# Access Compliance Report

## Public Rights-of-Way

### (Curb Ramps)

Intersection ID: 4999	Main Street: E_MALLARD_CREEK_CHURCH_RD	Cross Street: STONE_QUARRY_RD	Location: W
ADA ID: FBF871C974DF	Ramp Type: Perp	Initial Pass/Fail: Fail	Overall Compliance: No
Severity Score: 13.75			
Codes/Mitigation Info/Possible Solution		Field Measurements/Component Compliance

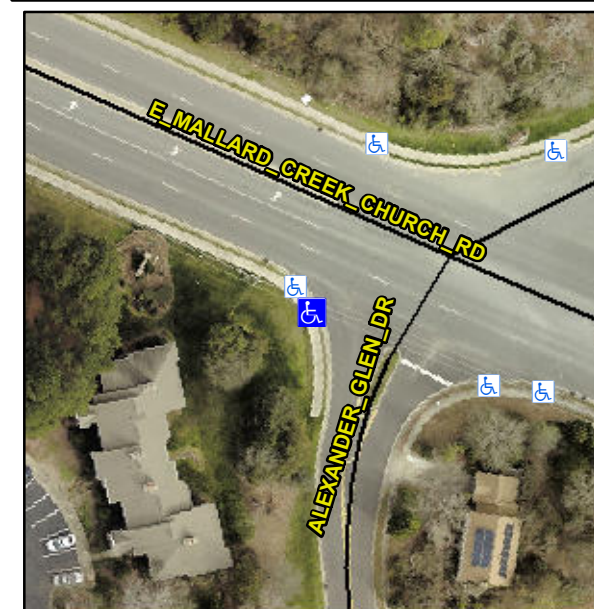
**R304.2.2, R304.5.3**

Compliance	Description	Data	Compliance	Description	Data
N/A	Ramp Length (in)	71.0	No	Ramp Slope (%)	10.3
Yes	Ramp Width (in)	48.0	No	Ramp XSlope (%)	3.5
N/A	Flare Type LT	N/A	N/A	Flare Type RT	N/A
N/A	Flare Slope LT (%)	N/A	N/A	Flare Slope RT (%)	N/A
N/A	Flare Traversable LT?	N/A	N/A	Flare Traversable RT?	N/A
N/A	Landing Length (in)	N/A	N/A	DWS Provided?	N/A
N/A	Landing Width (in)	N/A	N/A	DWS Contrast?	N/A
N/A	Landing Slope (%)	N/A	N/A	DWS Length (in)	N/A
N/A	Landing X Slope (%)	N/A	N/A	DWS Full Width?	N/A
N/A	Landing Curb? (Y/N)	N/A	N/A	DWS Offset (in)	N/A
N/A	Shared Landing?	N/A			
N/A	Gutter Ponding?	N/A	N/A	Gutter Slope (%)	N/A
N/A	Gutter Lip Ht (in)	N/A	N/A	Gutter X Slope (%)	N/A
N/A	Painted X Walk1?	No	N/A	Painted X Walk2?	N/A
	X Walk 1 Direction	To SE		X Walk 2 Direction	N/A
N/A	X Walk 1 Width (in)	N/A	N/A	X Walk 2 Width (in)	N/A
	X Walk 1 Slope (%)	1.1		X Walk 2 Slope (%)	N/A
	X Walk 1 X Slope (%)	2.7		X Walk 2 X Slope (%)	N/A

**Remove & Replace Entire Ramp.**
